# CITY OF ALBUQUERQUE

**RE: 1707 Powell Rd SW**  
**Grading and Drainage Plan**  
**Engineer's Stamp Date: 03/06/24**  
**Hydrology File: K12D039**

ENGINEER'S SEAL	LOT 9 POWELL GARDENS ADDITION 1707 POWELL ROAD	DRAWN BY DEM
DAVID SOULE REGISTERED PROFESSIONAL ENGINEER 14522	GRADING AND DRAINAGE PLAN	DATE 3-3-24
3/6/24	Rio Grande Engineering P.O. BOX 53924 ALBUQUERQUE, NM 87199 (505) 321-9099	1707 POWEL RD.DWG
		SHEET # C1
		JOB #

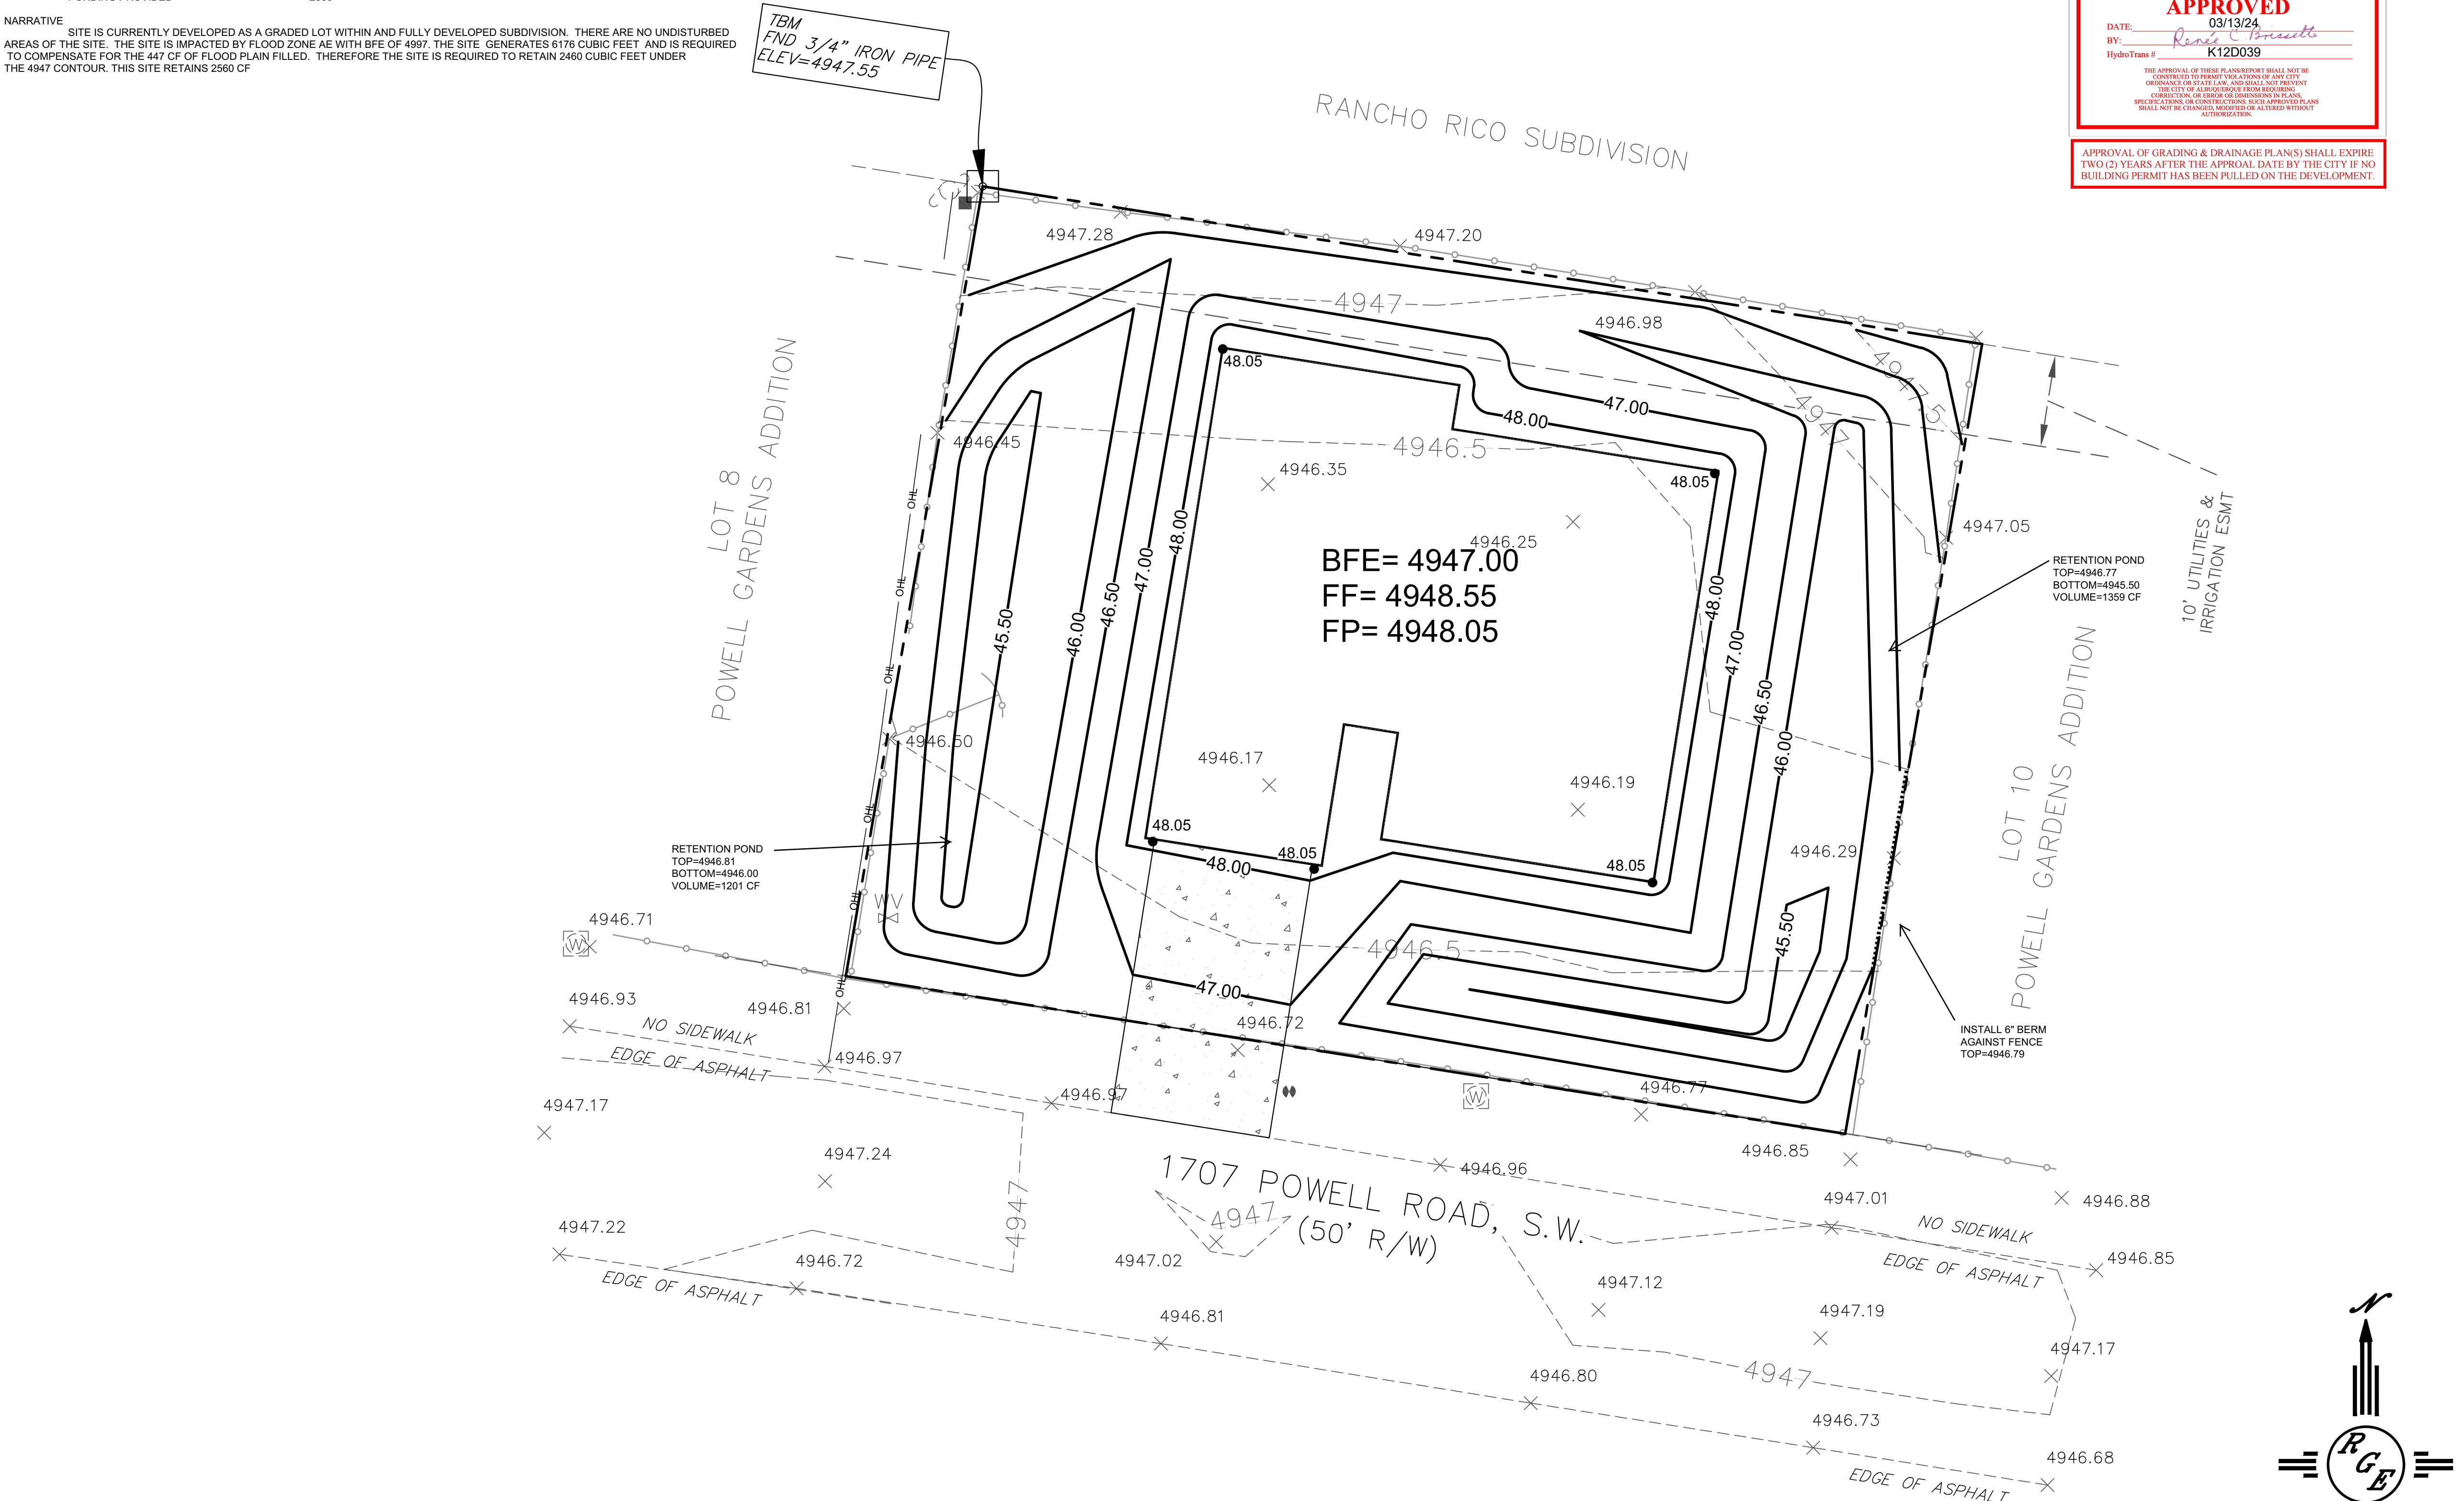
Based upon the information provided in your submittal received 03/06/2024, the Grading & Drainage Plan is approved for Building Permit and Grading Permit. **Since this site appears to need little grading, a pad certification is not needed for this project.** Please attach a copy of this approved plan in the construction sets for Building Permit processing along with a copy of this letter.

1. Engineer's Certification, per the DPM Part 6-14 (F): *Engineer's Certification Checklist For Non-Subdivision* is required.
2. Please provide an Elevation Certificate using the latest form from FEMA. Please note that this was updated last year.
